## The Hows, Whys and Fixes for Pegasus "Jitter"

Recent investigations into the reasons and possible cures of Pegasus screen Jitter have revealed that there are at least 4 distinct causes. This report explains the theory behind these causes and suggests some modifications to erradicate the jitter.

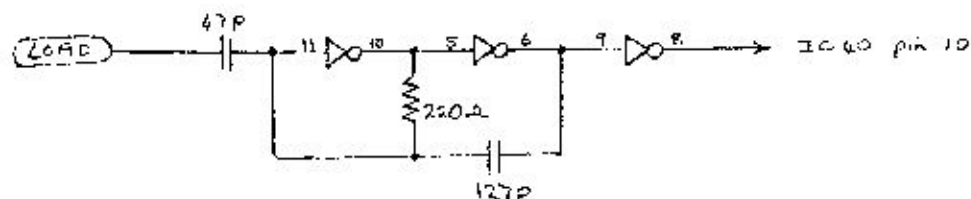
The frame rate for the video is initiated by a signal derived from the mains; Once the frame is started, everything is locked to the processor clock. So while the picture information doesn't jitter with respect to HSYNC and VSYNC, the frames themselves do jitter with respect to each other. In other words the VSYNC signals are not regular. Sometimes they are  $X \times 64 \text{ us}$  (HSYNCS occur every  $64 \text{ us}$ ) apart and sometimes they are  $(X + 1) \times 64 \text{ us}$  apart. Normal TV sets have an oscillator which likes to lock to regular VSYNC pulses. It will infact lock to a frequency with a period somewhere between  $X + 1$  and  $X$  times  $64 \text{ us}$ . Then what you get is a picture sometimes slightly above and sometimes slightly below the true position. The cure is to use some kind of divider to derive your 50Hz from the processor clock, instead of the mains. The following mod uses one IC and some existing gates on the Pegasus board.

The 74LS20 gate has tracks running to it which must be cut.  
 The 74LS04 becomes free from a modification to the dot clock oscillator which was given to us by G. Barbour of Christchurch.  
 This modification stops shimmer on the displayed characters and stabilizes the oscillator frequency.

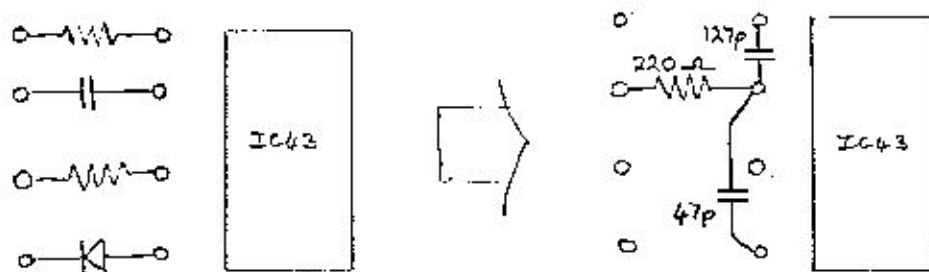
This modification only involves removing 4 components and replacing them with 3 components as shown.

The IC43 gate at pins 13 and 12 is freed for use in the 4020 mod.

## Type 2 Jitter

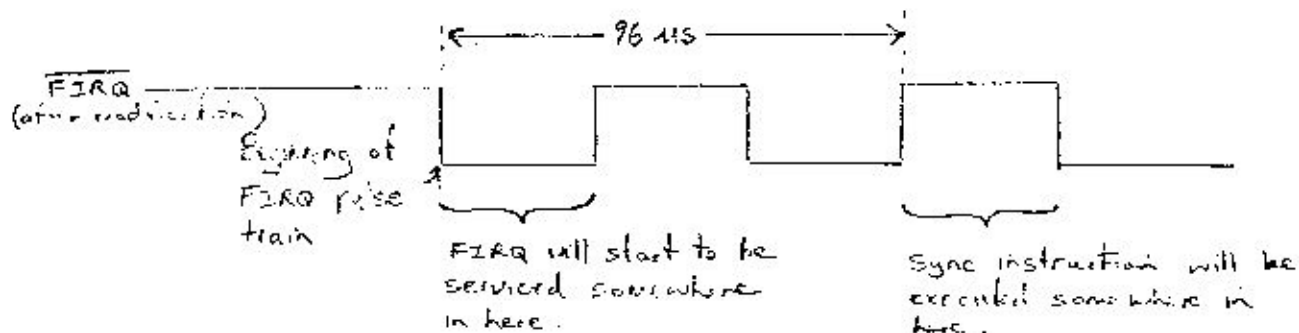
The FIRQ pulses generated by the existing Pegasus hardware are 8  $\mu$ s long. The 6809 chip however only checks the FIRQ pin after each instruction. Since 6809 instructions can take up to 20  $\mu$ s it is clear that it is possible for the chip to miss on FIRQ pulse. If it "sees" the following one then the whole picture will be 64  $\mu$ s too late i.e. one scan line too low on the screen. This causes jitter whenever programs with longish instructions are running.

The cure for Type 2 jitter is to take the FIRQs from the 74LS93 divider, IC7 pin 9. This is a square wave with 32  $\mu$ s each way. This modification also needs a new monitor version 2-3. The delays in this monitor are adjusted so that a) the picture is in the middle of the screen and b) the SYNC instruction is 96  $\mu$ s after FIRQ starts to be serviced. This ensures that the SYNC instruction is not executed while the FIRQ line is low, which would cause terrible sideways jitter.

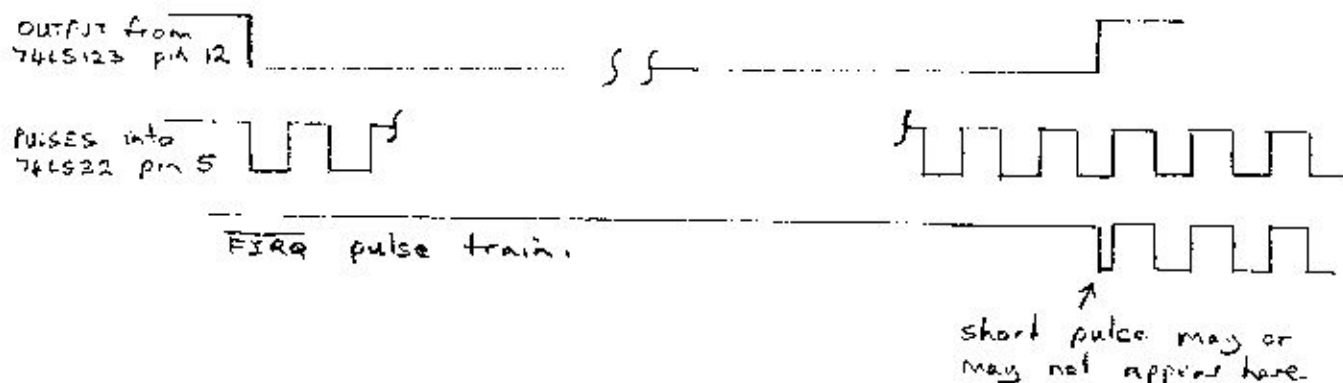
From this drawing it can be seen that 32  $\mu$ s is the ideal length for the FIRQ pulse (which is active low) because it gives an equal mark space ratio square wave. If the FIRQ pulse were any longer, then the period in which the FIRQ line is high becomes correspondingly shorter and it is then possible for the SYNC instruction to occur while the FIRQ line is low, giving sideways jitter.

If the FIRQ pulse is shorter than 20  $\mu$ s it is possible for them to be missed by the processor. In fact the full 32  $\mu$ s is better because it allows the programmer to mask off FIRQs for two or three instructions if he wishes, without missing an FIRQ.

So 32 us FIRQs are used. The time from the start of servicing of the FIRQ to the SYNC instruction in the monitor is adjusted to be 96 us. Also since the new FIRQs are out of phase with the old ones, the monitor has its delay that positions the picture in the middle of the screen adjusted.

The actual modification is done by cutting the track to the 74LS32 pin 5 and jumping this pin to the 74LS93 pin 9 (IC7) and getting a version 2-3 monitor.

### Type 4 jitter

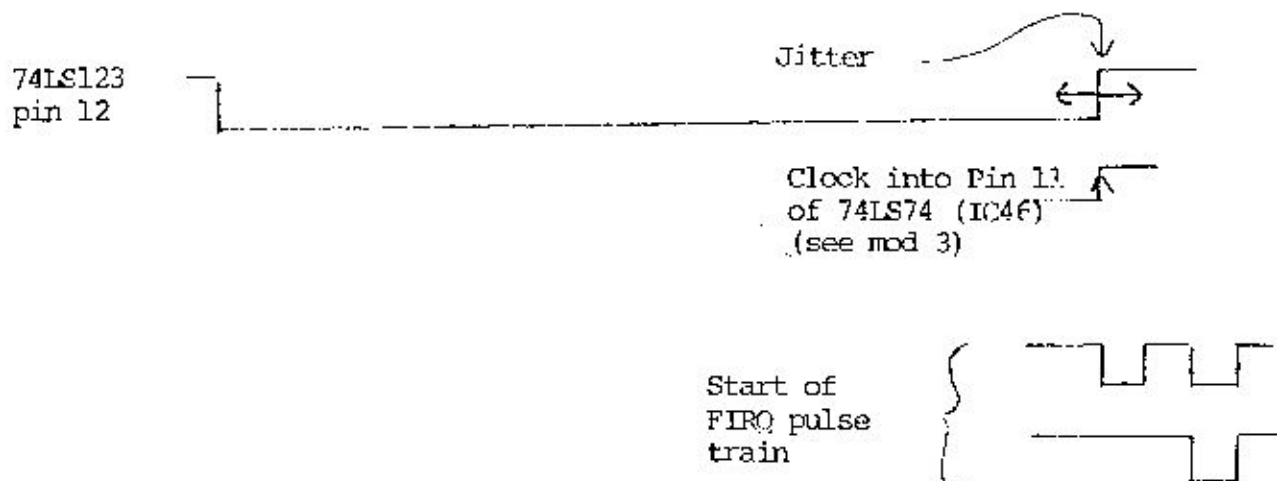
Type 4 jitter is again caused by the 74LS123. Using an oscilloscope it can be seen that a noticeable jitter occurs in the delay pulse whenever the Pegasus is running a program. When the trailing edge of the pulse falls on or near the clocking point explained for type 3 mod then the jitter in the 123 will cause the first FIRQ pulse to appear sometimes latter and sometimes earlier.

The only way to get round this is to bypass the 74LS123 altogether and use some pulses derived from the Type 1 jitter mod. (see the drawing for the 4020 mod). The existing track to 74LS74 IC6 pin 3 must be cut and taken to the spare nand gate as shown. This will give a picture nicely in the middle of the screen. (vertically)
